SAFETY EVALUATION BY THE OFFICE OF NUCLEAR REACTOR REGULATION
RELATED TO AMENDMENT NO. 229 TO FACILITY OPERATING LICENSE NO. DPR-28

ENTERGY NUCLEAR VERMONT YANKEE, LLC
AND ENTERGY NUCLEAR OPERATIONS, INC.
VERMONT YANKEE NUCLEAR POWER STATION

DOCKET NO. 50-271

Fig. 1: Vermont Yankee RELAP5 Nodalization

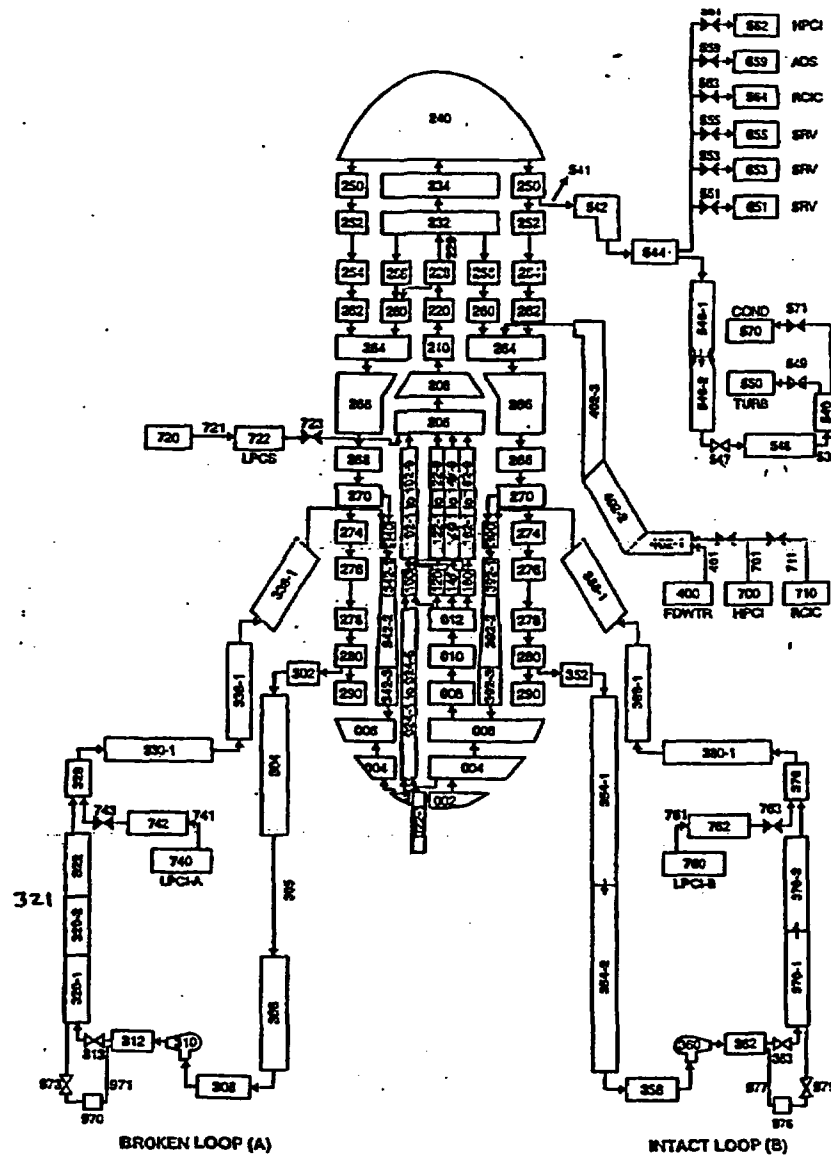
Figure 1 presents the RELAP5/MOD3 model of the VYNPS NSSS. As stated above, the RELAP5/MOD3 deck obtained from the licensee was modified to reflect the higher power level and the GE-14 fuel design.

Fig. 2: Break Mass Flow Rate vs Time

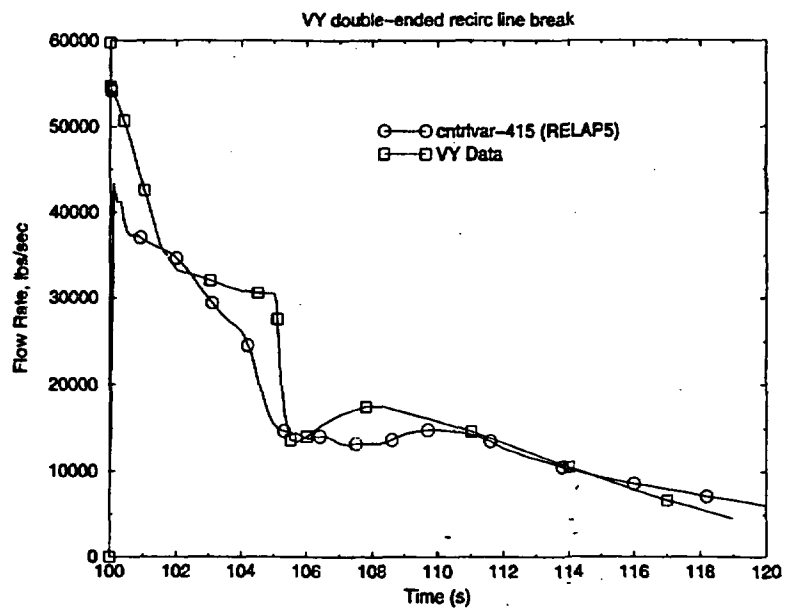
Figure 2 presents the mass flow rate from the break in the suction line. This flow rate consists of the break flow exiting both sides of the double-ended guillotine break in the recirculation line. To model the double-ended break, the break junctions are located at the exit to volume 304 and the inlet to volume 306 in Figure 1. The Henry-Fauske critical flow model in the RELAP5/MOD3 code was activated to predict the break flow. Inspection of Figures 2 and 3 shows that the RELAP5 code confirms the conservative nature of the VYNPS calculation at EPU conditions.

Figure 2.8.7-7
 Void Reactivity Coefficient vs. Instantaneous Void Fraction at an Exposure of 0 GWd/t

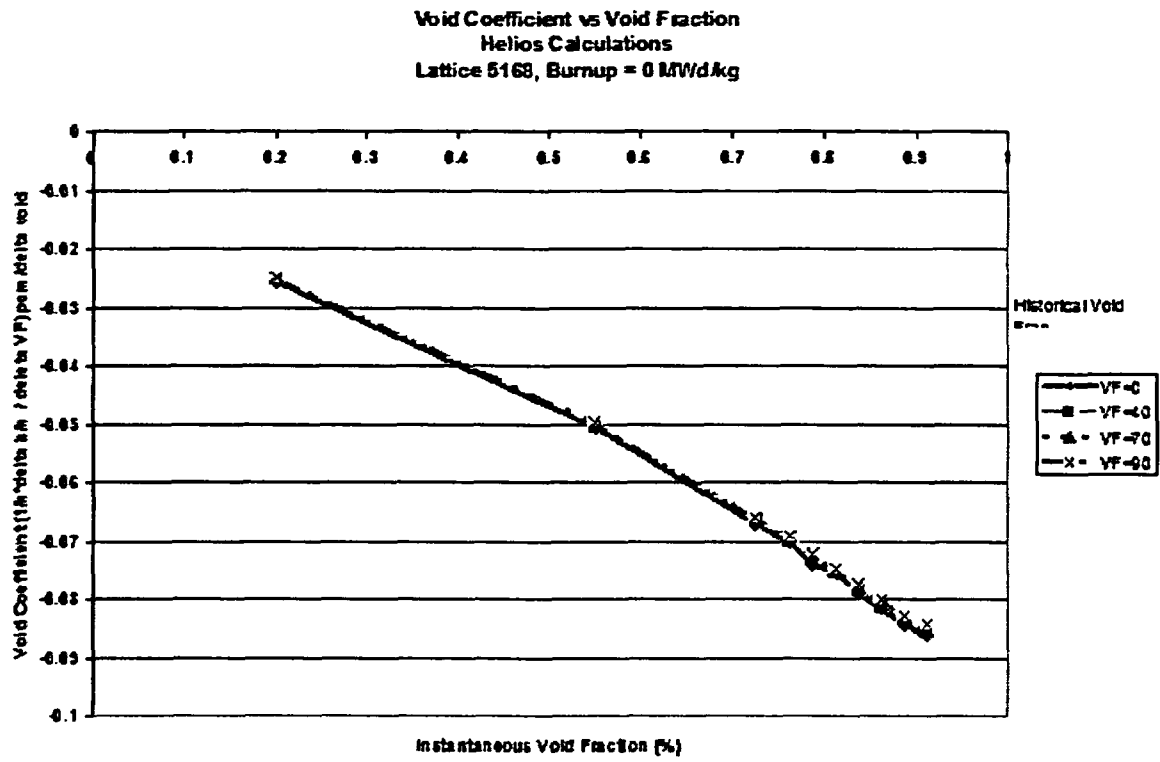
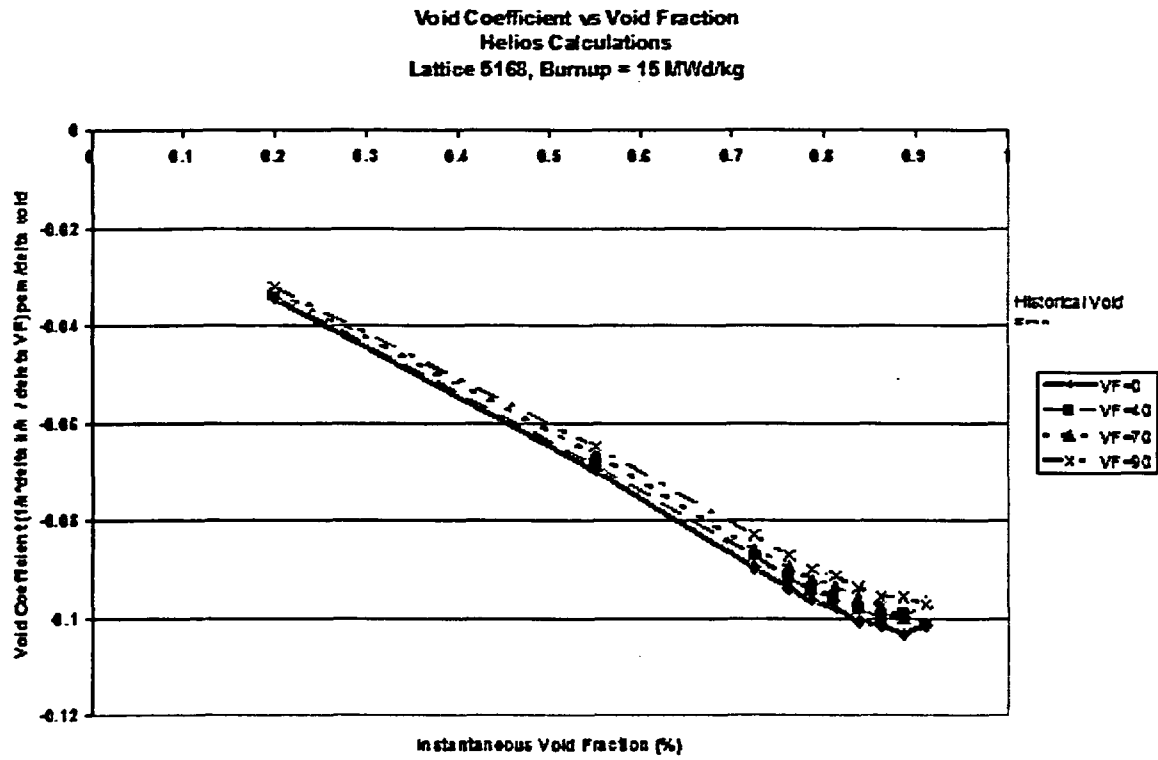
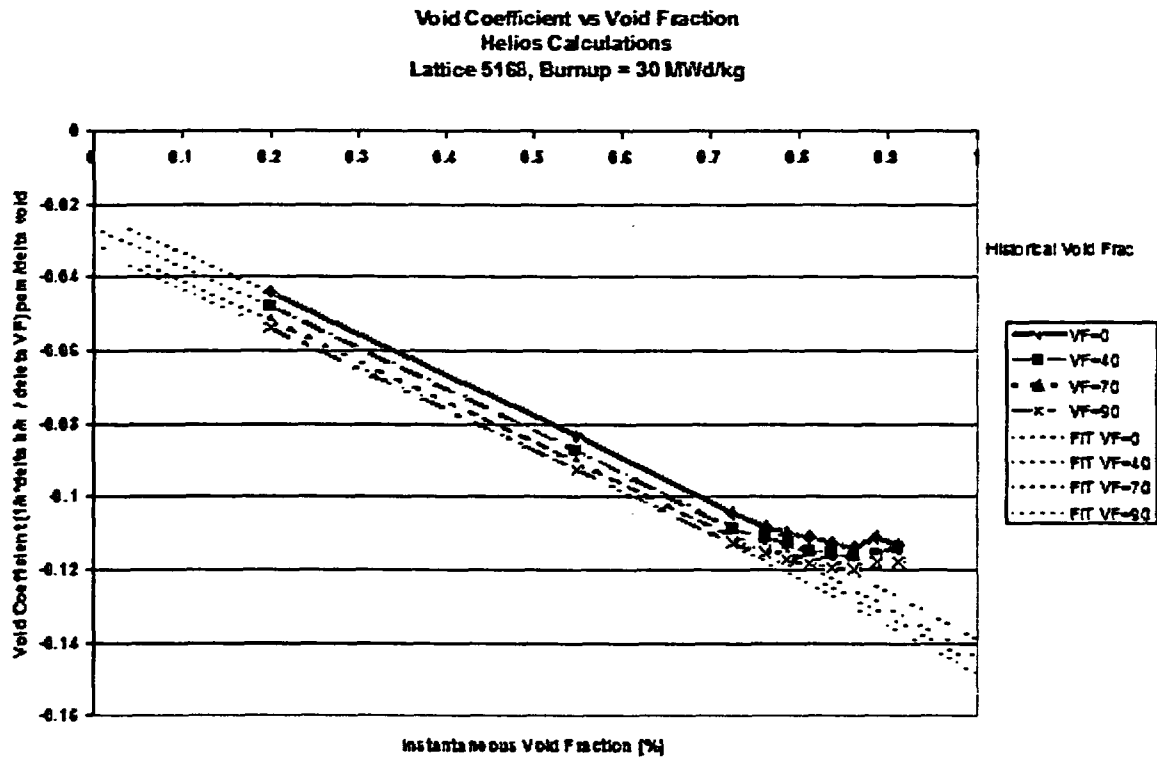
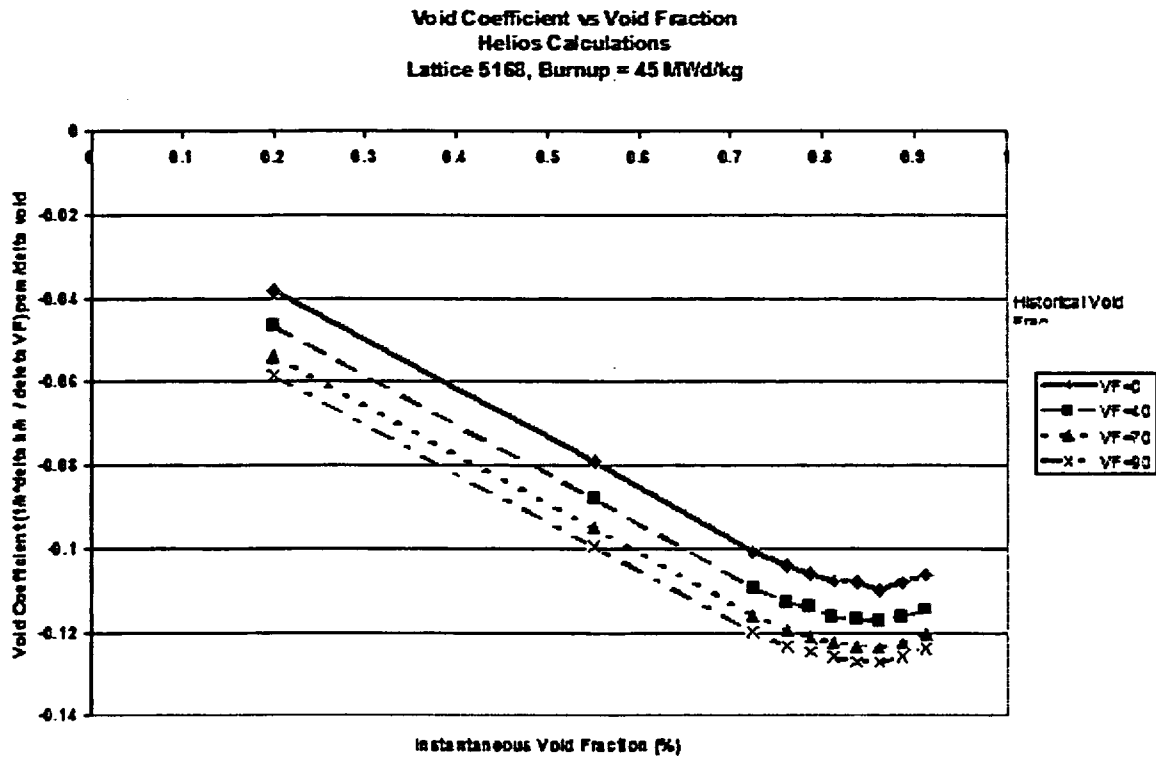
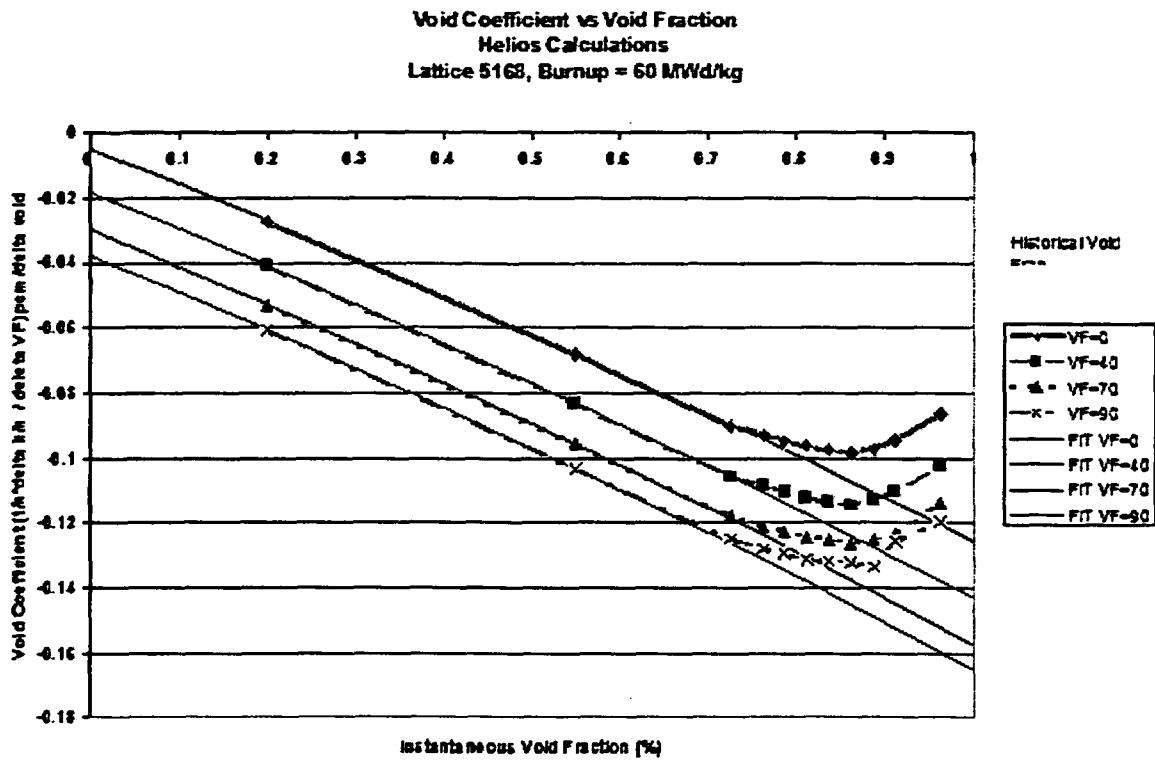
Comparisons of the void reactivity coefficients for the different void history cases and exposures are presented in Figures 2.8.7-7 through 11. Note that additional instantaneous branch points were calculated at the higher void conditions to resolve the non-linearity of the void coefficient with respect to instantaneous void fraction at high burnups. The impacts of the different void histories are evident at the higher void fractions with the increasing differences in the void reactivity profiles with increasing exposure (see Figure 2.8.7-11, for example). The difference in the profiles from that at a void history of 40% represents a potential error resulting from GE's methodology. In addition, the deviation of the void reactivity from a linear variation represents an error that results from the quadratic extrapolation used in GE's methodology. As shown in these figures, at high void fractions and high exposures the profile deviates from linear.

void branches only at 40% void history) against void reactivity coefficients calculated at different void histories with exposure. A plot showing the potential errors is presented in Figures 2.8.7-7 through 2.8.7-11. These figures show that the fitting process results in increasing errors with exposure and burnup (as previously discussed, based on the void reactivity coefficient plots). The errors for exposures of about 30 GWd/t and less are consistent with the [[]] uncertainty assumed in the ODYN analysis. However, for higher exposures at high void fractions the error increases to more than 30%.

Figure 2.8.7-19
Comparison of TGBLA-6 and CASMO-4 Kinf Values for Lattice 6996

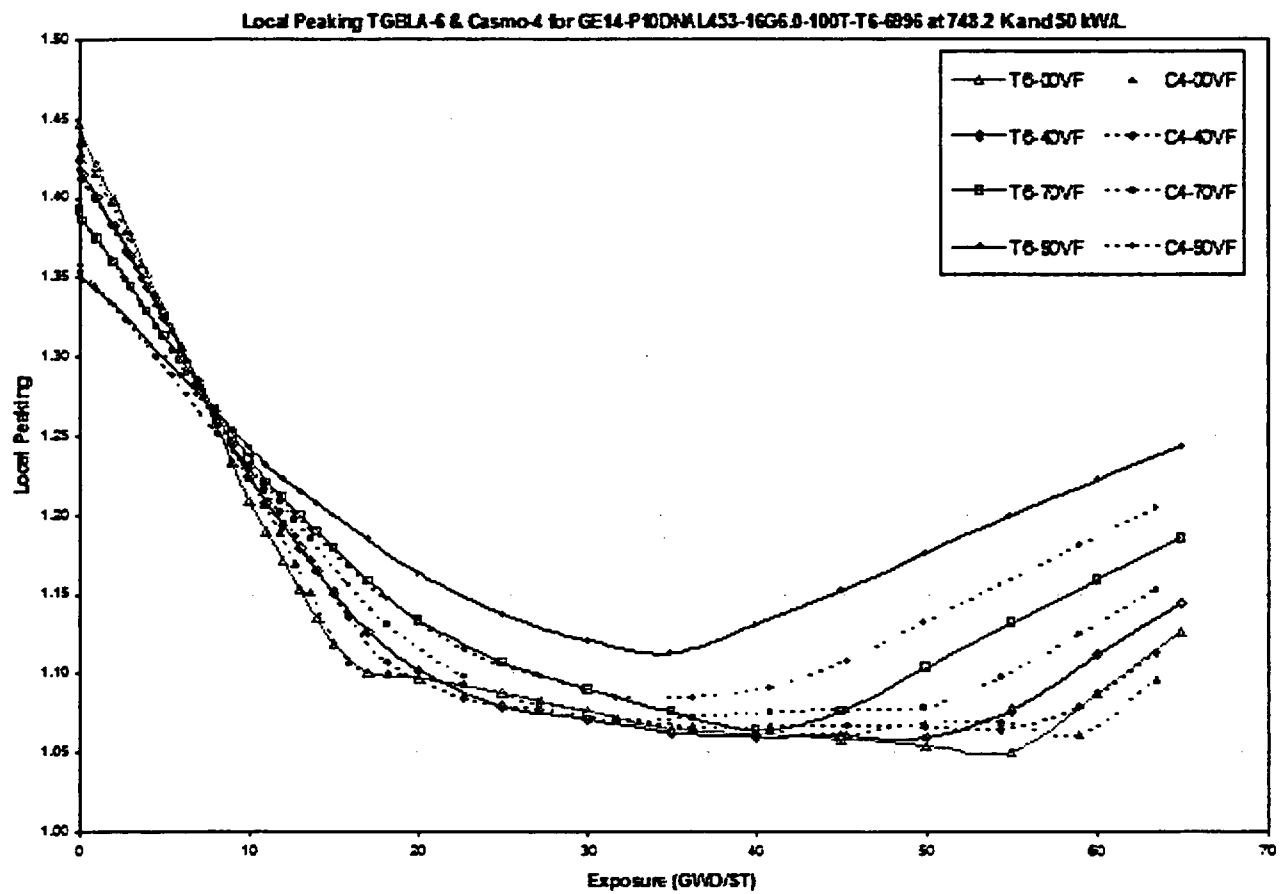
Figures 2.8.7-19 and 2.8.7-20 provides two K_{inf} vs. exposure curves for historical void fractions of 40% and 70%. The calculations were performed with an instantaneous void fraction of 0%. Therefore, the difference at high exposure is caused by differing isotopic compositions resulting from the depletion at different void histories. As these figures show, the impact of void history at high exposures is significant (greater than 5% delta k). Confirmatory analyses performed with HELIOS, presented in Figure 2.8.7-21, show a similar trend and include data for a historical void fraction of 90%.

Figure 2.8.7-22
Comparison of TGBLA-6 and CASMO-4 Local Peaking for Lattices 6996

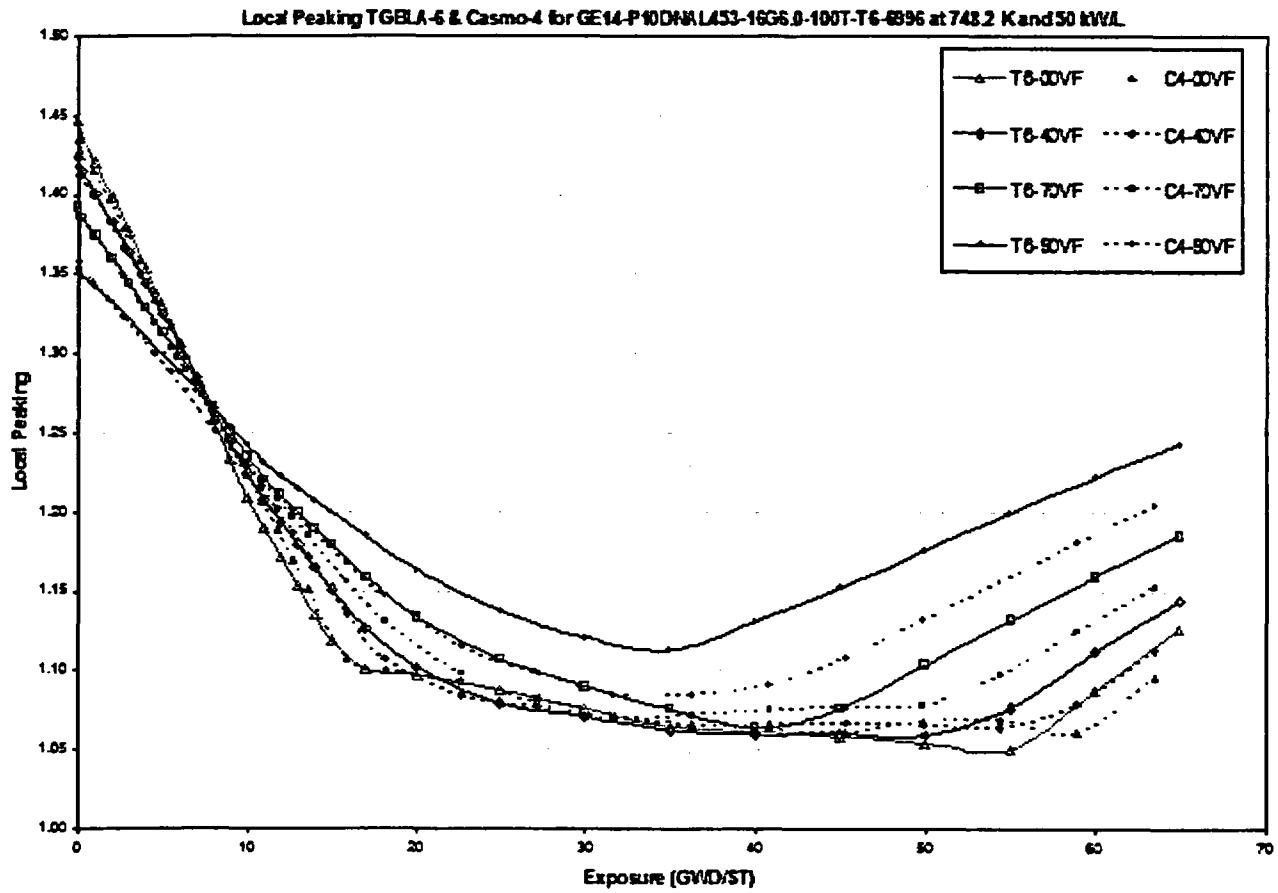
The pin peaking factor (Figure 2.8.7-22) shows good agreement at zero exposure, when the power peaking is the most significant. Differences increase with exposure resulting in several percent at burnups of 60 GWd/ST. Generally, the TGBLA-6 local peaking factors are larger than CASMO-4 and therefore will be more conservative in regards to pin exposure and LHGR. Note that at high exposures (greater than 30 GWd/ST), the power peaking is the largest for bundles with the highest void history. However, given that the power generation in this highly burned fuel is low, the net result is that the overall LHGR (a product of the region average power and the local power peaking) will be lower than that earlier in the exposure history, where the differences are smaller. However, the LHGR limit is lower at higher fuel exposures. Therefore, if spectral shift strategy is employed, as proposed in the expanded operating domains for EPU plants, with the upper nodes depleting at high void conditions and a top-peaked power distribution, both the bundle power and the pin power peaking would be high, at the most limiting kW/ft exposures.

Figure 2.8.7-23
TGBLA-6 / CASMO-4 RMS of Lattice Pin Power Peaking

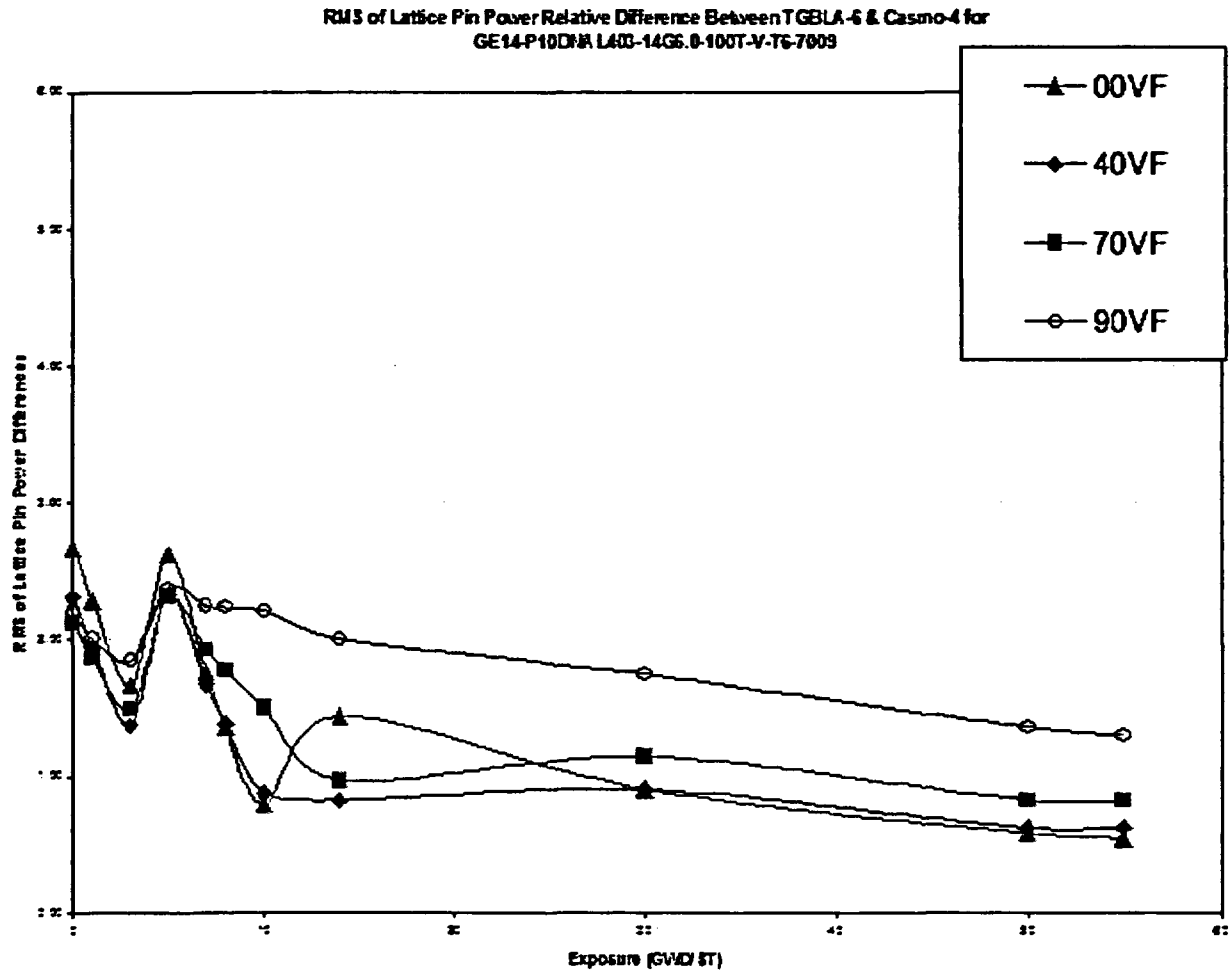
Figure 2.8.7-23 shows the root-mean-square (RMS) of the differences between TGBLA-6 and CASMO-4. The RMS error is used in development of the SLMCPR. Previous analysis comparing TGBLA-6 and MCNP (Reference 69, Enclosure 3) had shown that for a variety of lattices and exposures, that the RMS difference is [] However, in these comparisons the isotopic concentrations were taken from TGBLA and used in MCNP and, therefore, errors in depletion were not included. The results in this figure show that on a code-to-code basis that, for the lower void fractions, the RMS difference at low exposures and at high void fraction exceeds the [] RMS value, with maximum differences of about 2.5%. For the burnups above the gadolinium burnout and for lower void fractions, the differences are consistent with the [] value. Note that the results for the 90% void fraction presented in Figure 2.8.7-23 does not include potential errors caused by the quadratic fit and extrapolation used in GE's
